# Access Compliance Report Public Rights-of-Way (RR Crossings)

| Intersection ID: 51371                  | Main Street: UNIVERSITY_POINTE_BV | Location: N/A                           |
| ADA ID: 0DA08A0380E0                    | Overall Compliance: No            | Severity Score: 0.0                     |

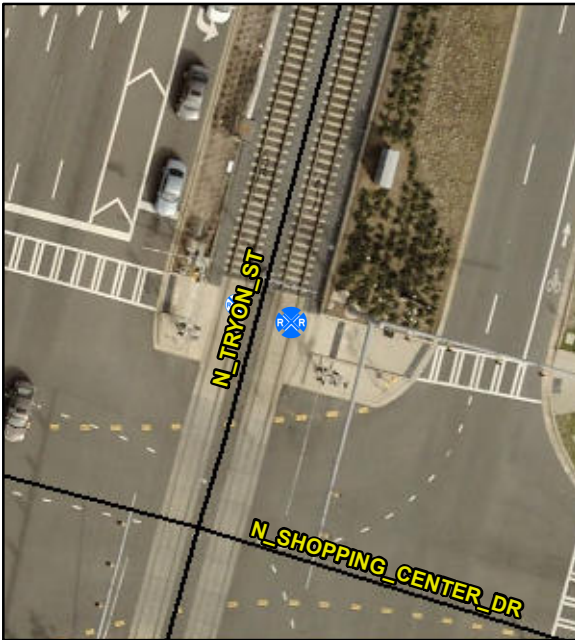
**R302.7.4**

| Compliance | Description         | Data      |
|------------|---------------------|-----------|
| No         | Flangeway Gap (in)  | 2.5       |

**Remove & Replace Walking Surface  
Adjacent to Rail.**
